New Severe-Duty Taillight and Trailer PDMs (Power Distribution Modules)

54-224

**Freightliner
Service Bulletin**

Description of Revisions: *This bulletin replaces the version dated August 2008. The part numbers in Fig. 1 have been updated.*

Fig. 1, New PDM Mounting Brackets

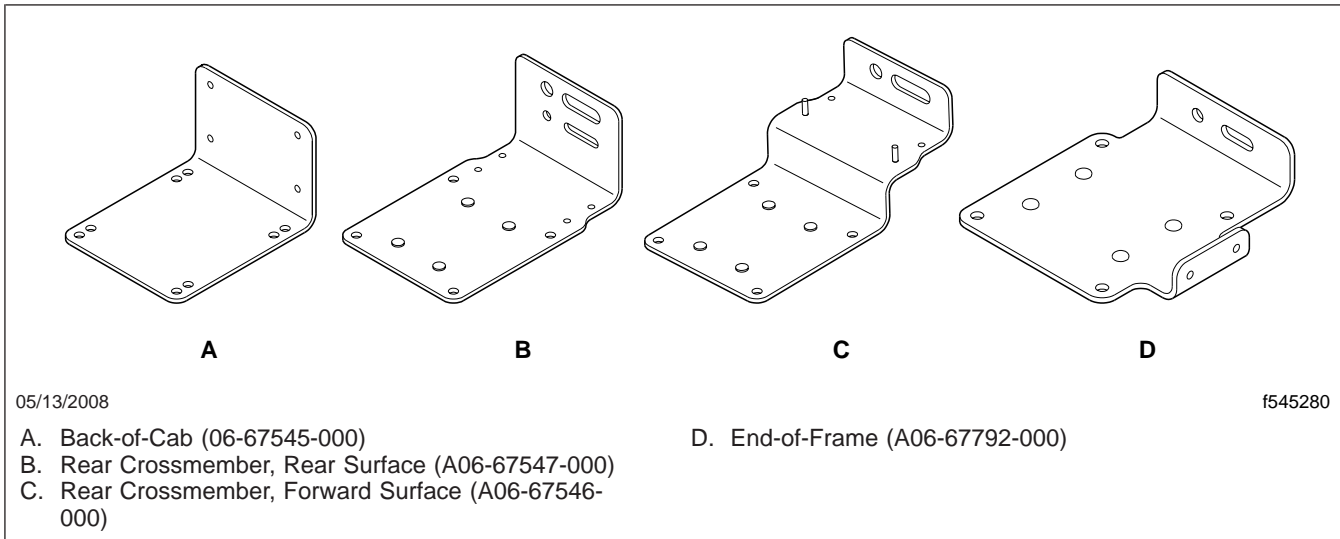
The new PDMs will connect to the existing wiring with no modifications; however, because they have a larger footprint, it is necessary to replace the existing PDM mounting bracket.

Fig. 3, Correct and Incorrect PDM Harness Connections

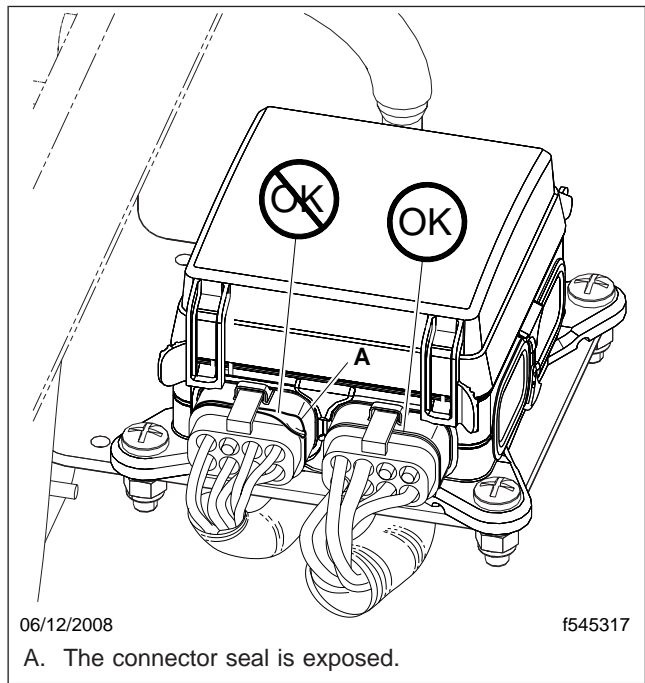
- 9.4 Apply a small amount of dielectric grease, such as Nyogel 760G, to each terminal in the PDM connector.
 - 9.5 Attach the two harness connectors to the PDM.
 - 9.6 Using the applicable fasteners, connect the power cable to the PDM. Tighten the nut(s) 13 lbf-ft (18 N-m).
10. As needed, secure the harnesses and the connectors. The harnesses should be routed so the wires are not pulling the connectors out of the PDM or pulling against the wire seals. See [Fig. 3](#).
- Where possible, route the cables and harnesses so they come from underneath the PDM to prevent water from flowing down the cable to the PDM.
